# Access Compliance Report

## Public Rights-of-Way

Intersection ID: 10025384	Main Street: E_9TH_ST	Cross Street: N/A	Location: W
ADA ID: A6ED31B552E5	Ramp Type: PerpDiag	Initial Pass/Fail: Fail	Overall Compliance: No
Severity Score: 22.5			
Codes/Mitigation Info/Possible Solution		Field Measurements/Component Compliance

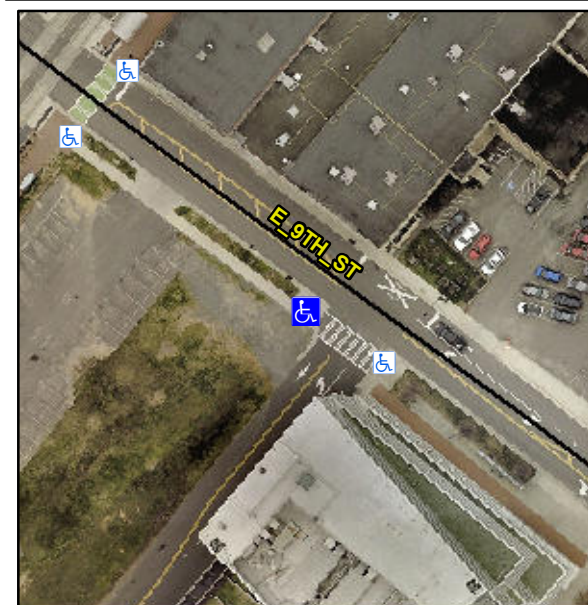
**Remove & Replace Curb Ramp With Two New Directional Ramps or Equivalent.**

**R304.5.1, R304.2.2, R304.5.3**

Compliance	Description	Data	Compliance	Description	Data
N/A	Ramp Length (in)	72.0	No	Ramp Slope (%)	10.5
No	Ramp Width (in)	46.5	No	Ramp XSlope (%)	2.3
N/A	Flare Type LT	N/A	N/A	Flare Type RT	N/A
N/A	Flare Slope LT (%)	N/A	N/A	Flare Slope RT (%)	N/A
N/A	Flare Traversable LT?	N/A	N/A	Flare Traversable RT?	N/A
N/A	Landing Length (in)	N/A	N/A	DWS Provided?	N/A
N/A	Landing Width (in)	N/A	N/A	DWS Contrast?	N/A
N/A	Landing Slope (%)	N/A	N/A	DWS Length (in)	N/A
N/A	Landing X Slope (%)	N/A	N/A	DWS Full Width?	N/A
N/A	Landing Curb? (Y/N)	N/A	N/A	DWS Offset (in)	N/A
N/A	Shared Landing?	N/A			
N/A	Gutter Ponding?	N/A	N/A	Gutter Slope (%)	N/A
N/A	Gutter Lip Ht (in)	N/A	N/A	Gutter X Slope (%)	N/A
N/A	Painted X Walk1?	Yes	N/A	Painted X Walk2?	No
	X Walk 1 Direction	To SE		X Walk 2 Direction	To NE
N/A	X Walk 1 Width (in)	143.0	N/A	X Walk 2 Width (in)	N/A
	X Walk 1 Slope (%)	2.4		X Walk 2 Slope (%)	0.3
	X Walk 1 X Slope (%)	2.3		X Walk 2 X Slope (%)	2.4
